Royal Clarence Yard: Parking 17/00290/FULL

Deputation from Residents Association and Gosport Access Group and Disability Forum - Illustrations

Lack of safe level access across site

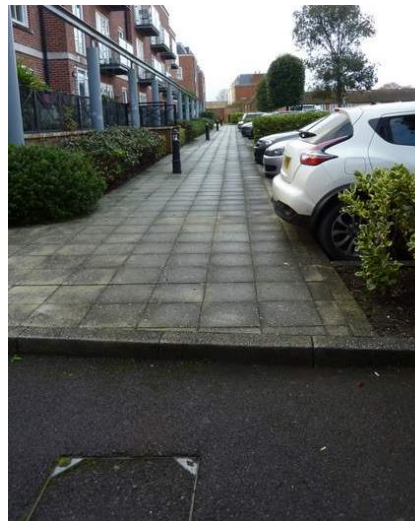
Dropped kerbs by disabled parking bays only work if there are dropped kerbs and safe crossings between car park and destination...

Otherwise a wheelchair user has no option other than to wheel along the road (unsafe)

Disabled parking bays located where no dropped kerb can be provided (By bike sheds in Zone 3)

Unsafe pedestrian & access routes across the site

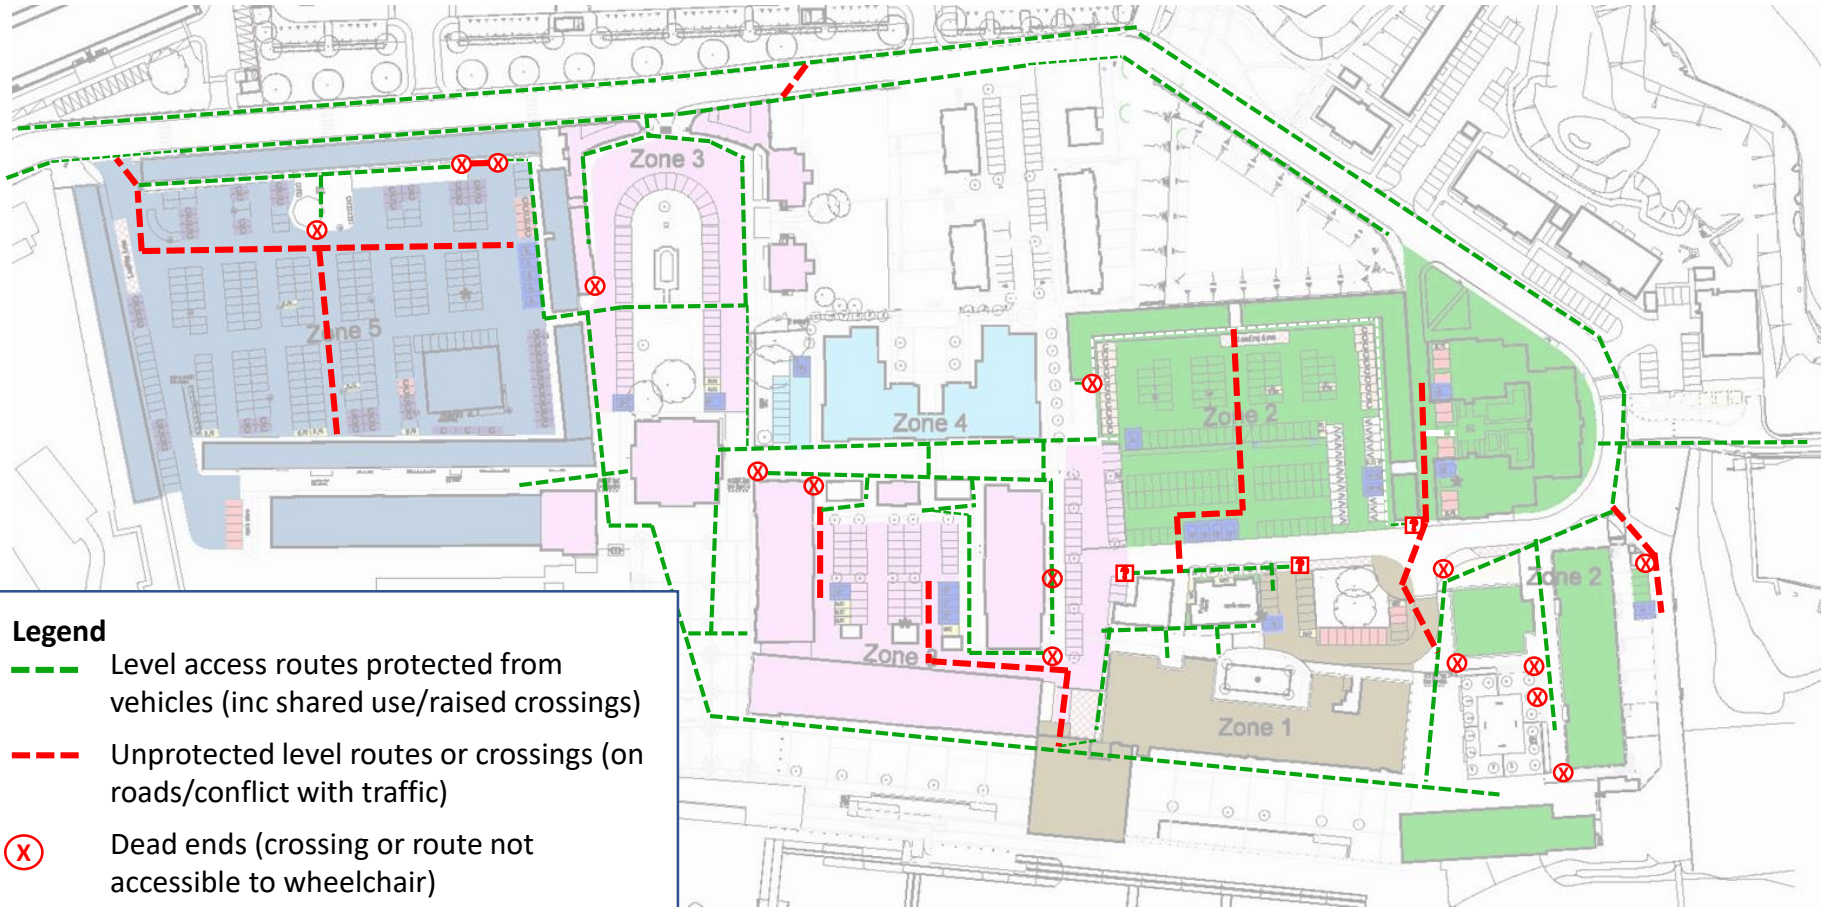
Cooperage Green perimeter path blocked by marina trolleys

Even if you can access the pavement by the disabled parking bay, that's no use if there is no dropped kerb or level access at your destination – or if the pavement is blocked en route (12-15 places across the site)

12-15 problem routes/crossing/access points which result in wheelchair users having to take to the road
No logical/coherent safe level access across the site to and from car-parks

North Meadow /Zone 2 Car Park: Lighting levels at night

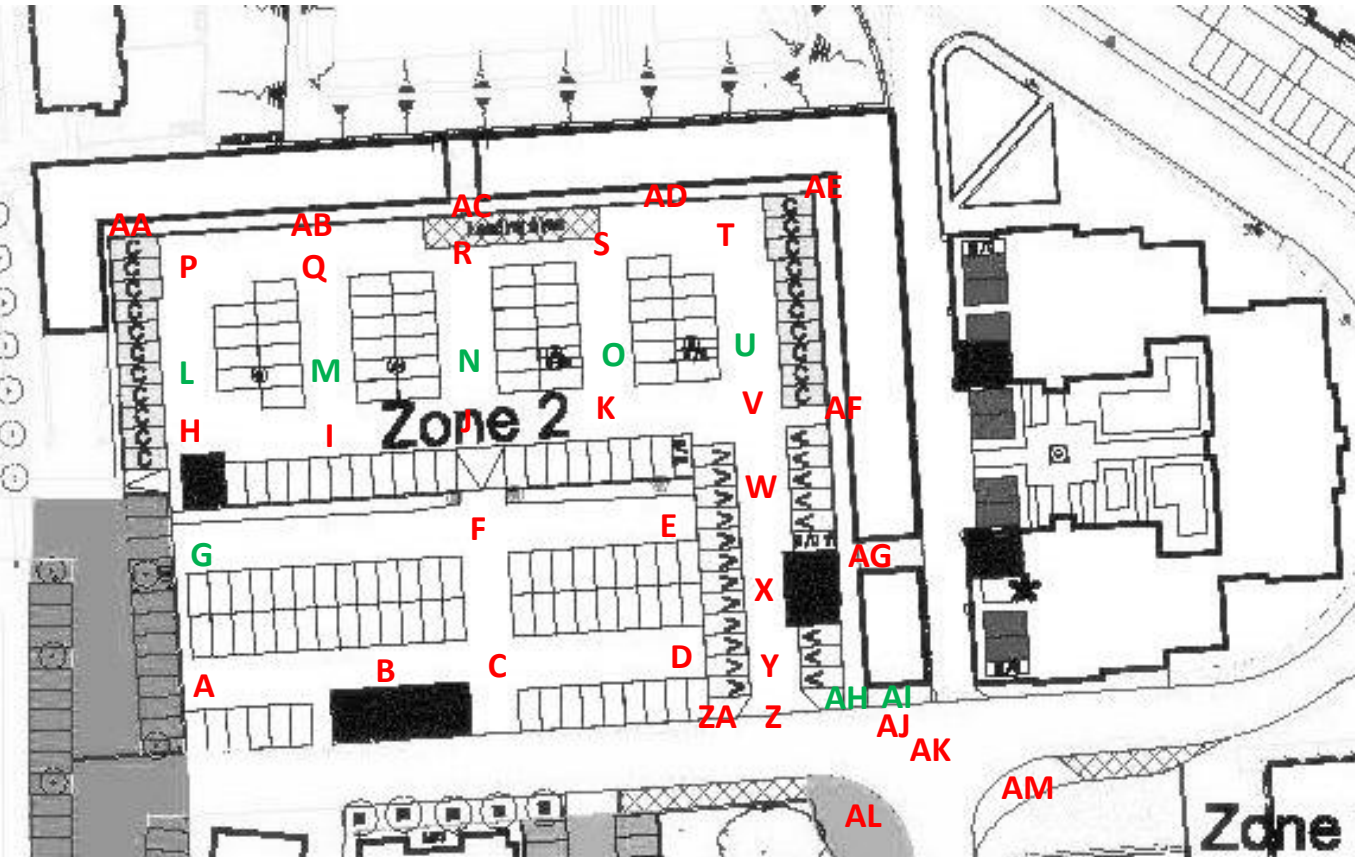
- A = lux level too low to register – unacceptable**
- G = lux level acceptable**

- Lighting levels fall well below National/EU standards for exterior car-park lighting (BS 12464: 2014)
- No lighting provided on former NM4/5 footprint (A-G) – only designated as a car park in 2015
- Inadequate lighting levels by disabled parking bays (B & X-AG)
- Inadequate lighting on main pedestrian crossing to Waterfront and Gallon/Ledwell (AJ-AM)
- No lighting for pedestrian access from car park to NM7 building (AG)

North Meadow Visitor Parking: Reduction in spaces

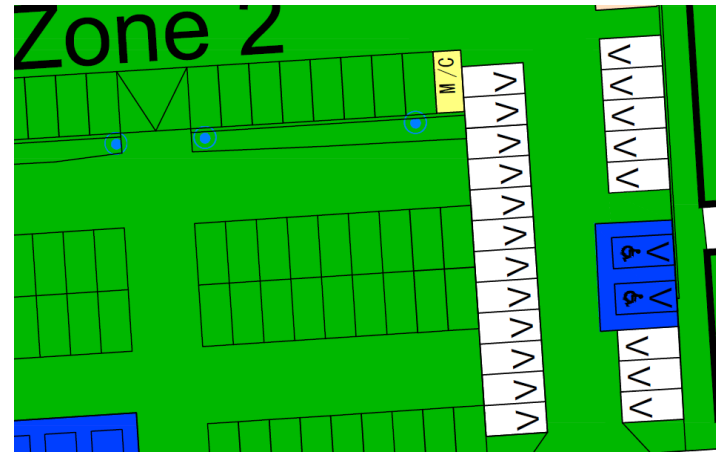
- 34 Visitor parking bays
- 1 Disabled Visitor space

- 20 Visitor parking bays (-41%)
- 2 Disabled Visitor spaces

- NM Visitor Parking area serves Galleon Place, Ledwell Court, Granary & Bakery, NM7, Salthouse, Slaughterhouse and commercial units at the North of the site
- 2015 Parking and NM7 permissions based on NM7 Visitors parking in Cooperage Green (0.4km away).
- Applicant now confirms that NM7 Visitors can park in North Meadow Visitor Parking area – just as availability of Visitor spaces is reduced.
